CERTIFICATE OF APPROPRIATENESS

**RE: Application Number 20-6987; 2447 Cass; Cass-Henry Historic District
Project Scope: Rehabilitate Apartment Building**

RE: 2447 Cass Avenue—Hotel Ansonia/Grande Apartments

Sheet
7A101

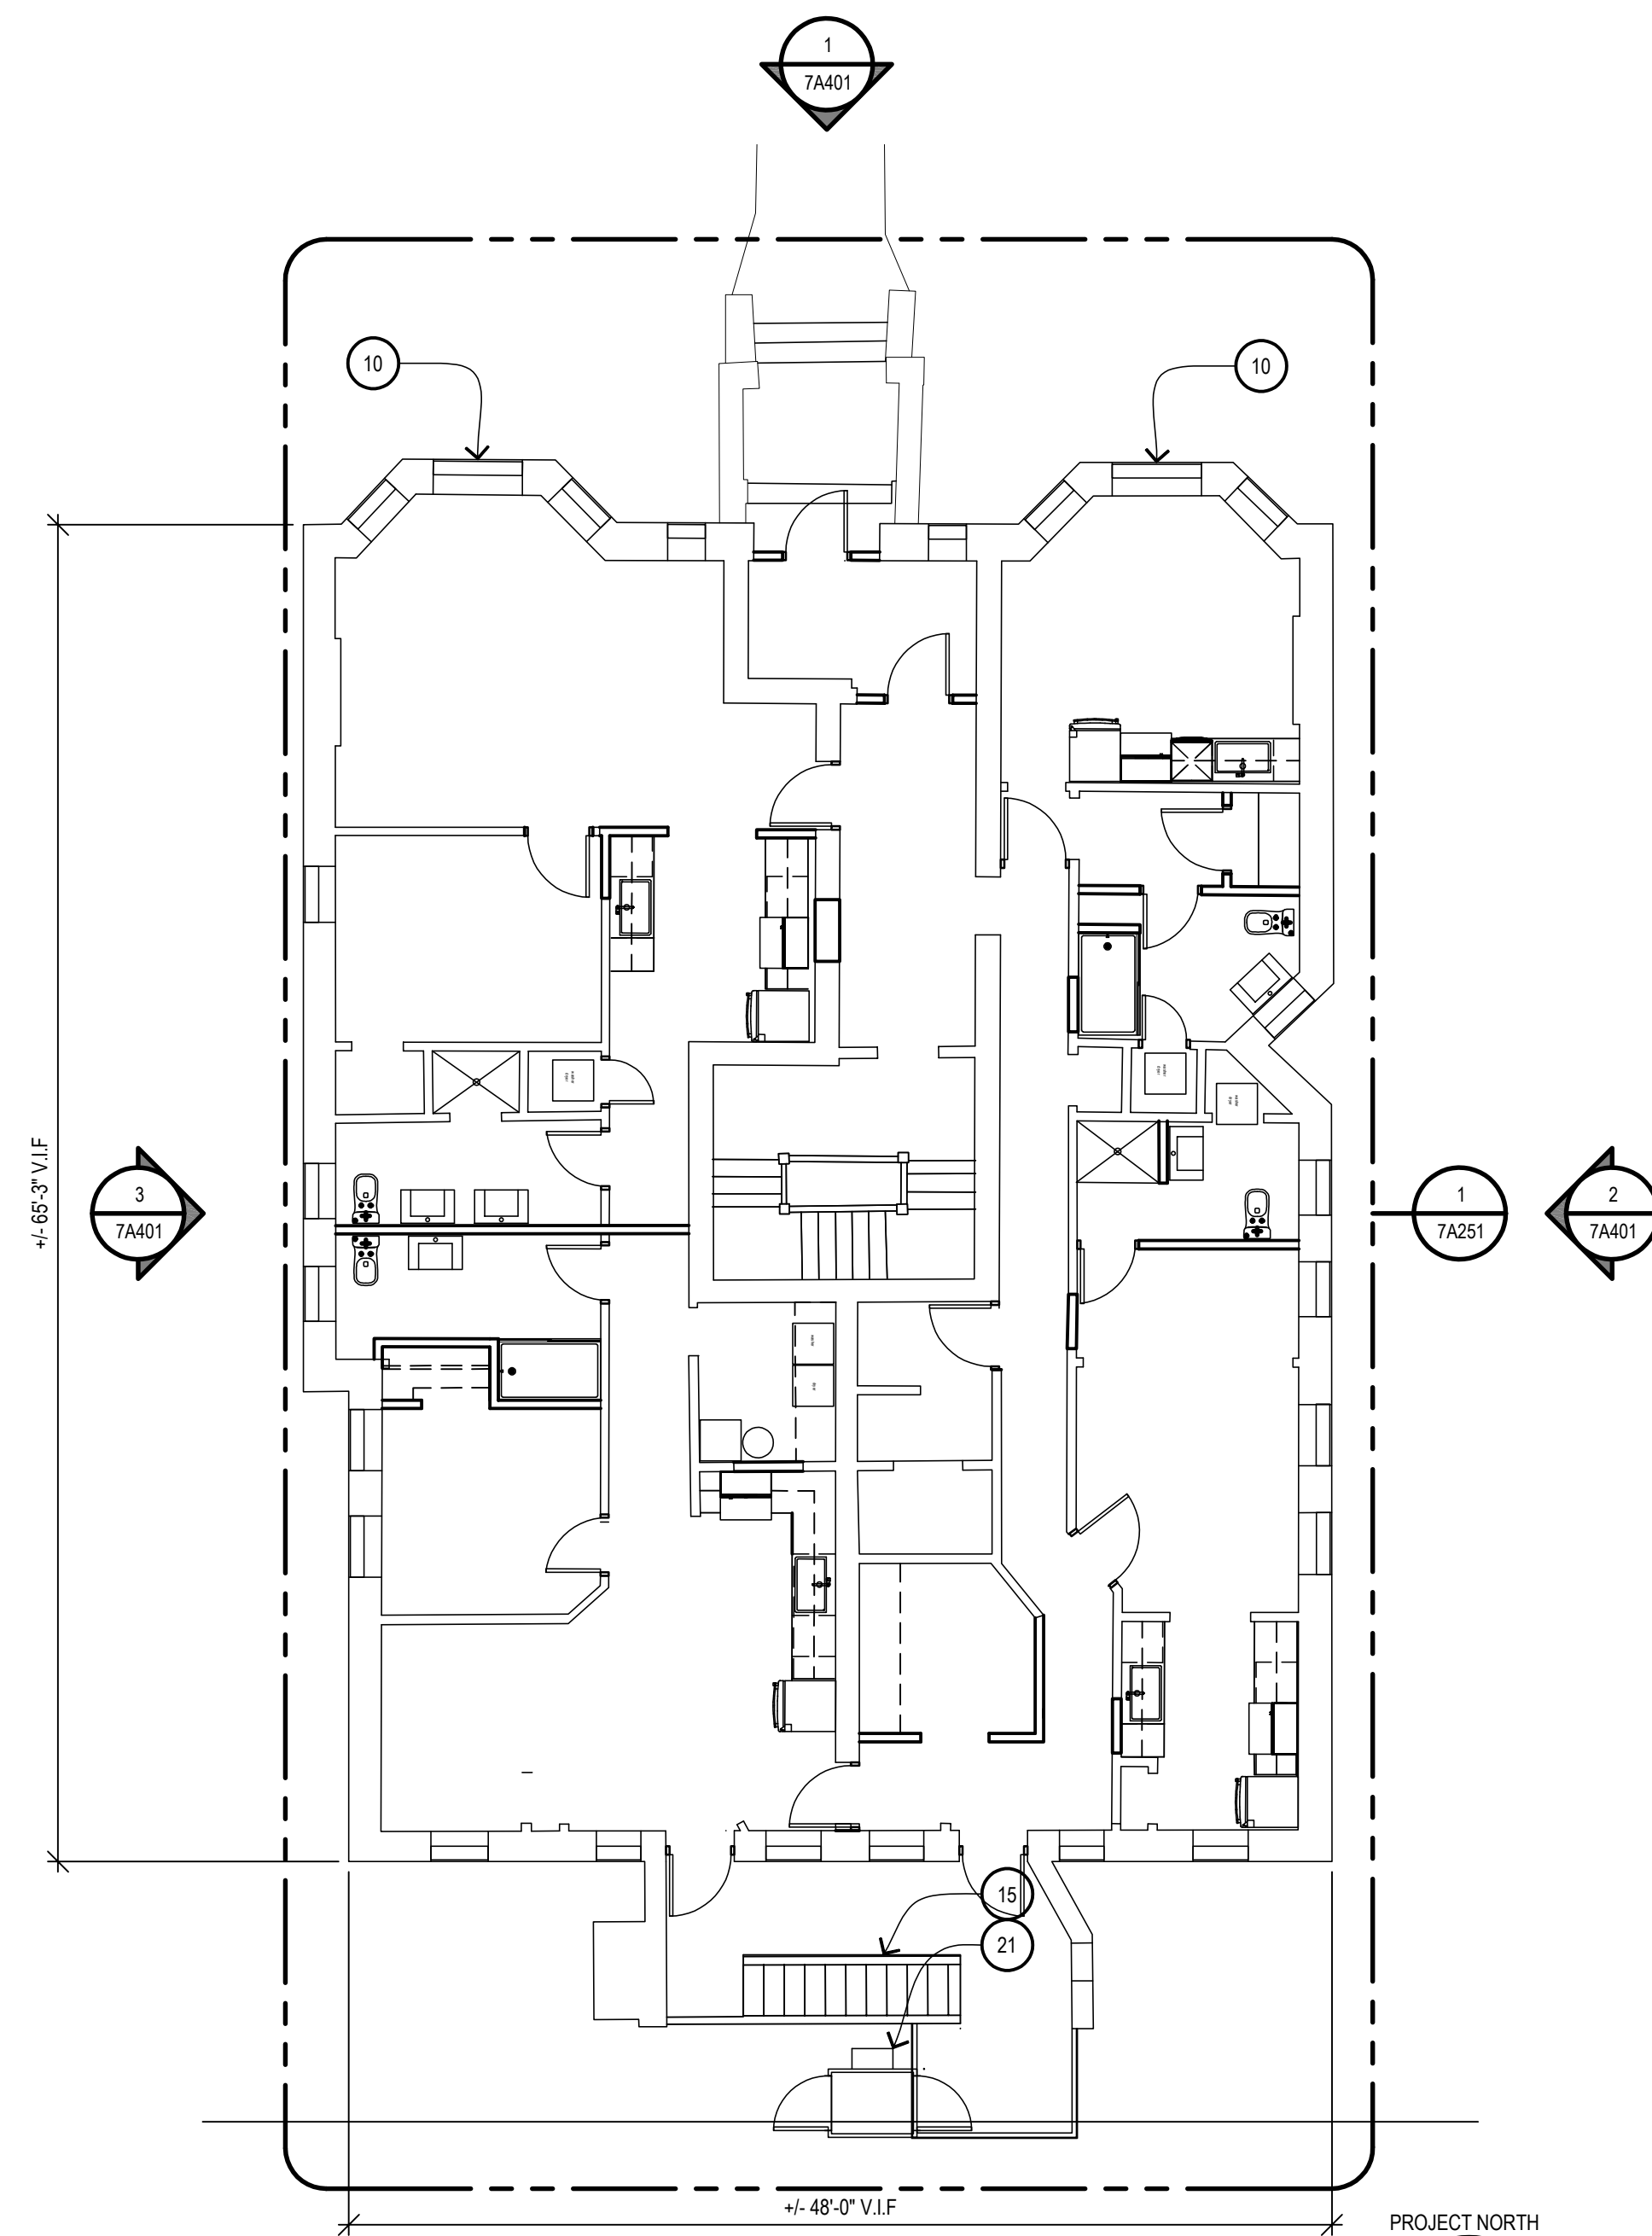
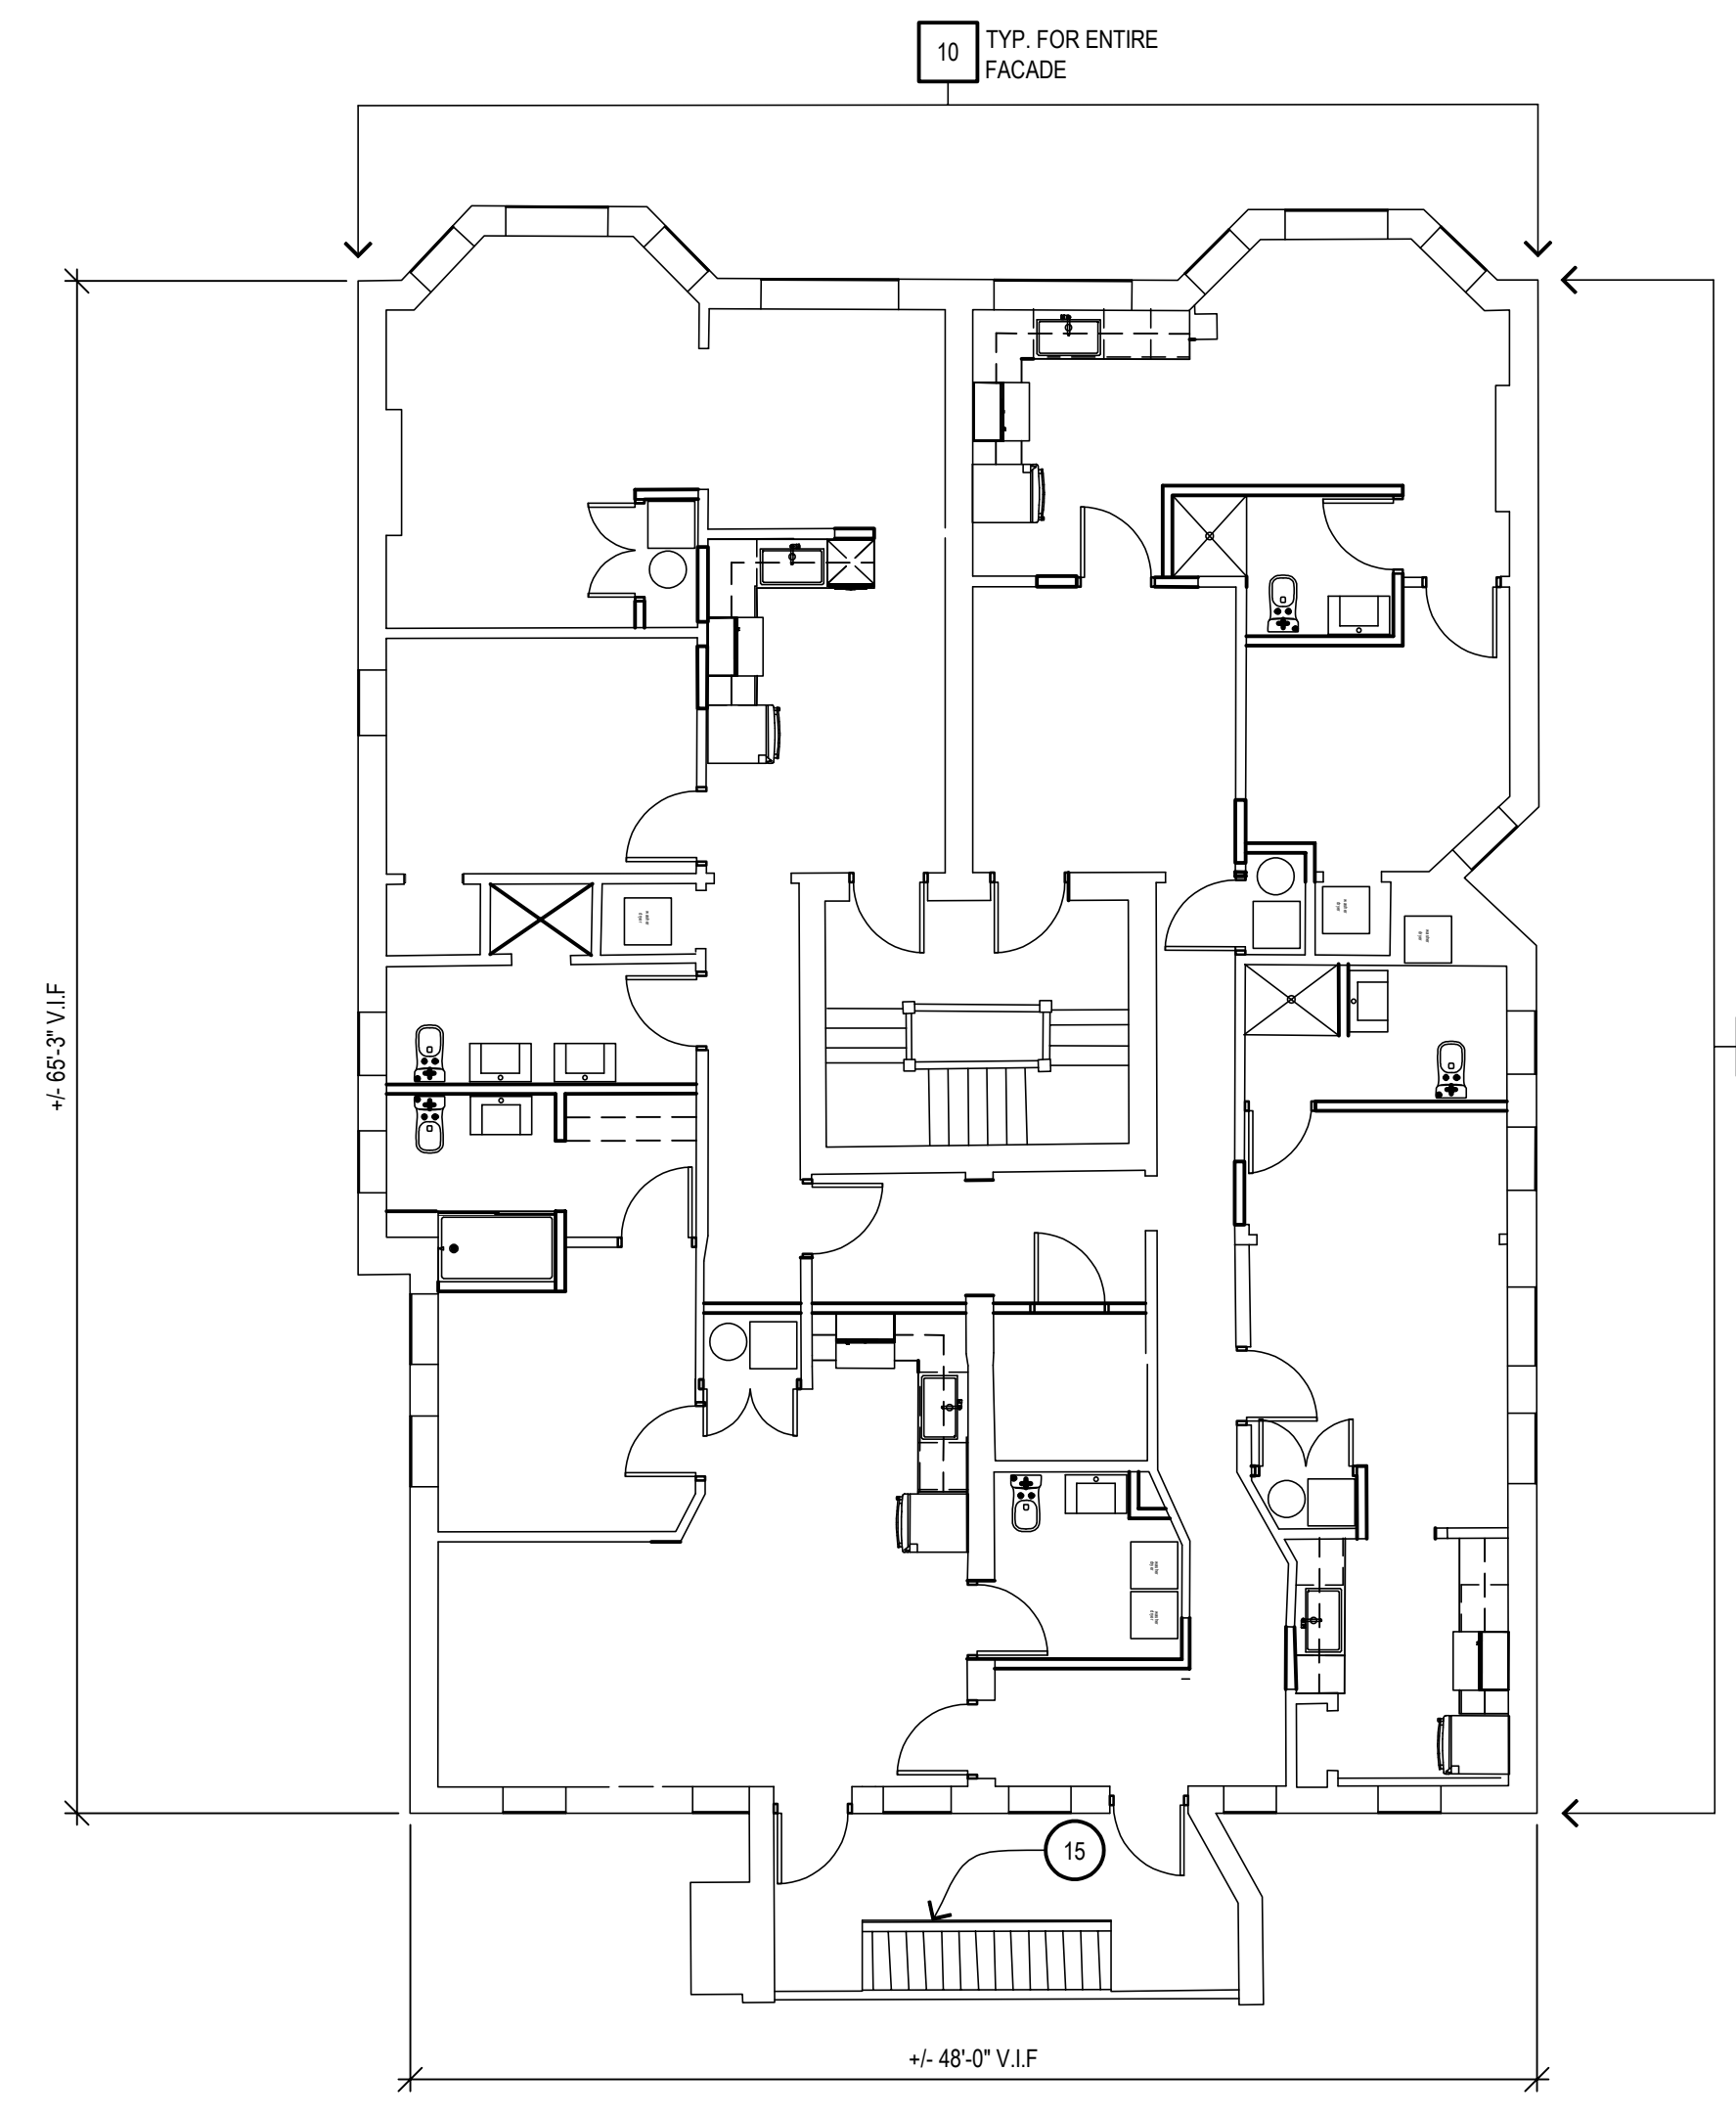
- *Current EPDM roof to be removed and replaced with a new EPDM roof*
- *Small condensers will be added to the center and western side of the roof with painted metal panel mechanical screens to obscure the condensers*
- *Small skylight in center of roof to be removed and replaced with a contemporary low-profile skylight structure*

And, as per the submitted documents, specifically drawings 7A101 (floor/roof plans) and 7A401, 7A401.1 (elevations).

- Staff review of the submitted construction drawings will include the identification of specific standards concerning repair and/or replacement of deteriorated character-defining features, and related standards concerning the qualifications of historic preservation contractors retained to perform the work.
- Staff review of the submitted construction drawings to specifically include review of specifications/cut sheets for lighting, windows, doors, ADA lifts, signage, paint removal, paint colors, and other exterior elements/selections not yet finalized, with staff authority to approve if per the Secretary of the Interior's Standards, the district's Elements of Design, and otherwise consistent with Commission intent and guidelines.
